STAFF RECOMMENDATION

300 Broadway

April 19, 2017

Application: Alterations-exterior lighting

Figure 1. 300 Broadway

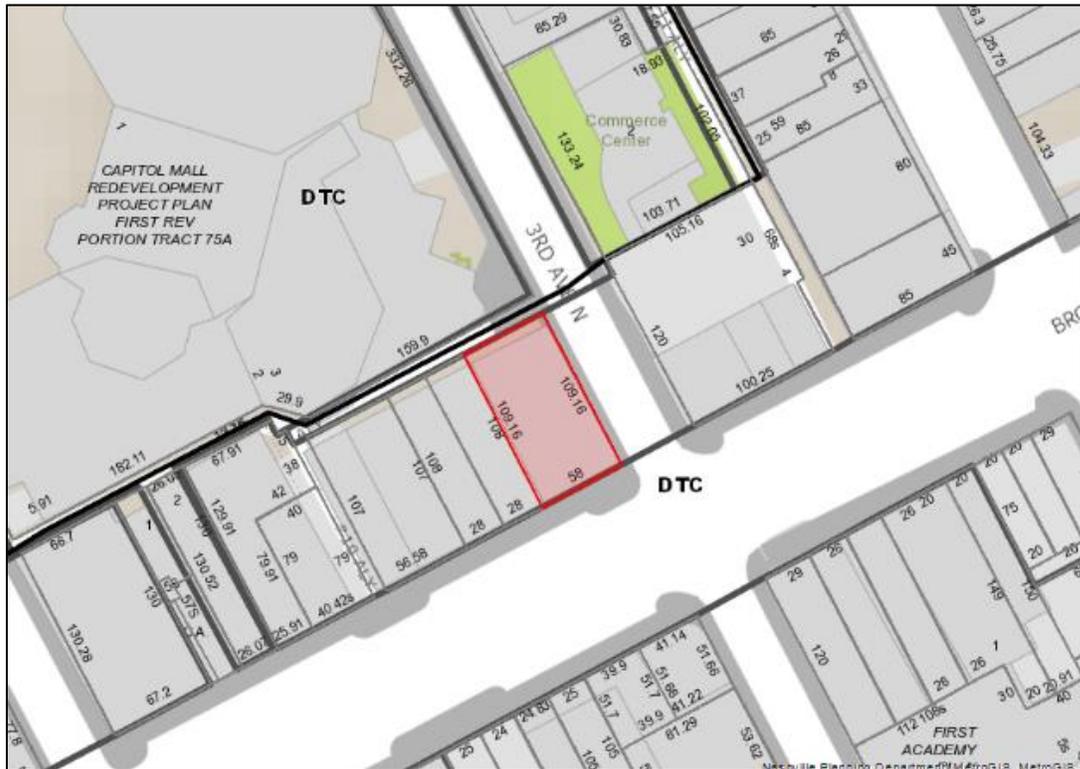
Analysis and Findings: The application is to add exterior lighting to the mechanical screen at the top of the building, on and above the cornice above the second level, above the cornice above the first level on the rear-side, and on each pilaster between the first and second levels.

Location & Visibility: The design guidelines allow for exterior lighting if it is concealed or unobtrusive; which is the case for all of the proposed lighting.

The lighting on the addition is inappropriate as the addition should be as minimally visible as possible. Internal lighting of the mechanical screen will only draw attention to the new construction, which is not the intent of the design guidelines for rooftop additions, which states that additions should “not be visually jarring or contrasting” to the historic building.

The up and down spotlights on each of the pilasters are appropriate as they highlight architectural features. They are visible but have a minimal design. The color of the can was not noted. Staff recommends a dark metal color, as allowed in the design guidelines, or one that is similar in color to the wall material.

The drawings note that the lights change colors. Illumination should be white as colored lights change the color of the building and would detract from the historic character of the building. No other buildings within a district have been approved for colored illumination.

Direction: Light should be directed towards the façade rather than outwards. All of the proposed lighting, with the exception of the rooftop mechanical screen lighting, is directed towards the building. The lighting on the rooftop is on the “inside” of the screen wall, providing internal illumination directed away from the building, and is therefore inappropriate. Staff recommends removal of the internal lighting of the mechanical screen.

1. Additional information be submitted regarding location, attachment and visibility, to assure appropriateness prior to permitting;
2. The KX5 lighting be removed as it is not directed towards the building, it is in an inappropriate location and it does not meet the design guidelines for rooftop additions.
3. The color of the KX2 fixture is a dark metal color or a color to match the building; and,
4. The color of all the illumination is white.
